# REGULAR MEETING OF THE
# CITY OF CONCORD
# DESIGN REVIEW BOARD

# REPORT TO DESIGN REVIEW BOARD

**Project Name**: La Vista Villas (PL131314-DR)

**Review Status**: Preliminary Review

ENGINEERED / TRUE CROSS SECTIONS

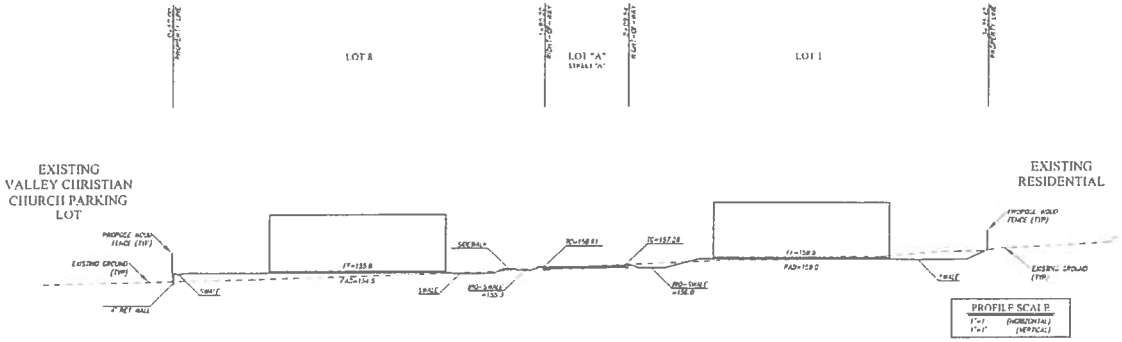
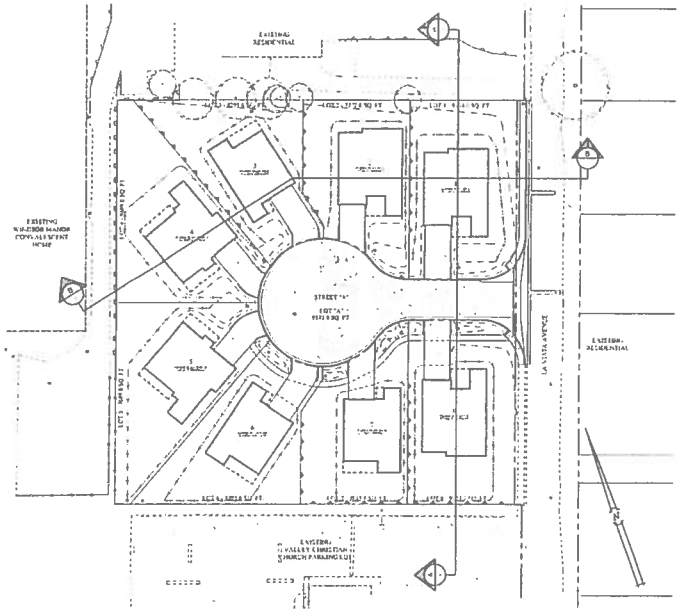
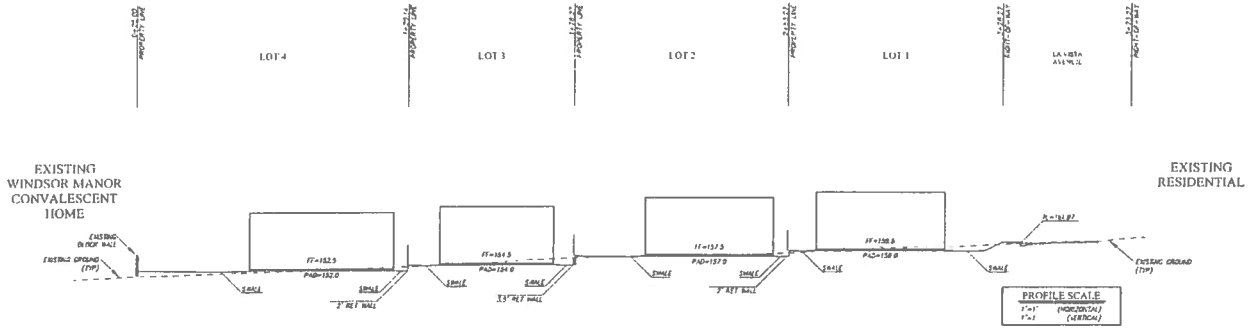
2. **Align cross-sections with proposed retaining wall details.**

*Proposed retaining walls are shown on the cross-sections per sheet C3.*

# PLANTING NOTES, PLANTING & FENCING DETAILS

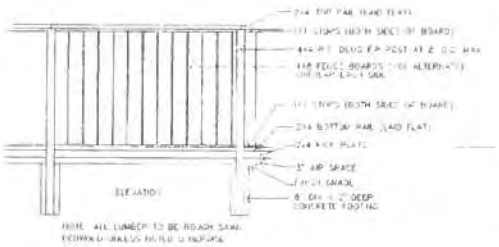
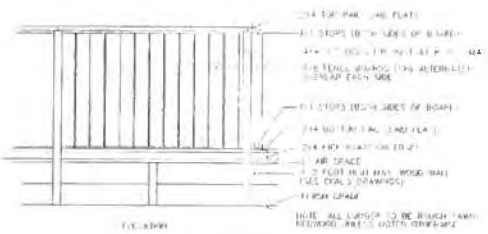
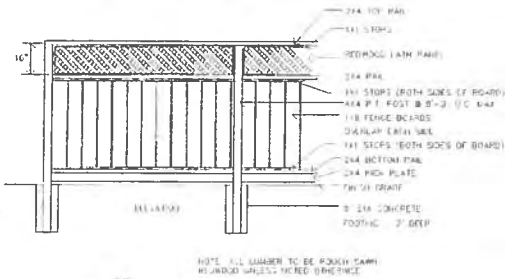
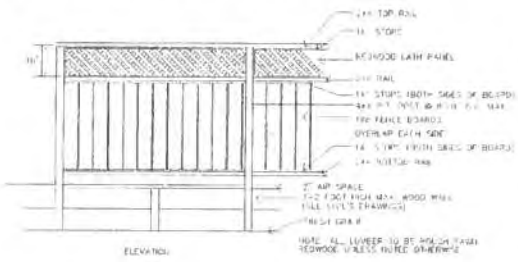
1. **Include detail bubbles for proposed fencing.**

10. **A six-foot tall masonry wall along the southern property line (adjacent to the church) is sufficient. Noise issues must be addressed via the masonry wall.**

11. **Provide heavy duty fencing at north and west property lines**

*A preliminary fencing plan is provided on sheet L-2 of Exhibit A, but detail bubbles for the proposed fencing are not shown on the site and preliminary grading plans.*

*A six-foot tall lath fence is proposed along the southern property line adjacent to lots 5, 6, 7, and 8. However, a six-foot tall masonry wall is not proposed on the preliminary fence plan.*

*A six-foot tall lath fence is shown along the northern property line and an existing six-foot high wall is shown on the western property line. The lath fence is similar to the good neighbor fence and is not what the Board would consider a heavy duty fence.*
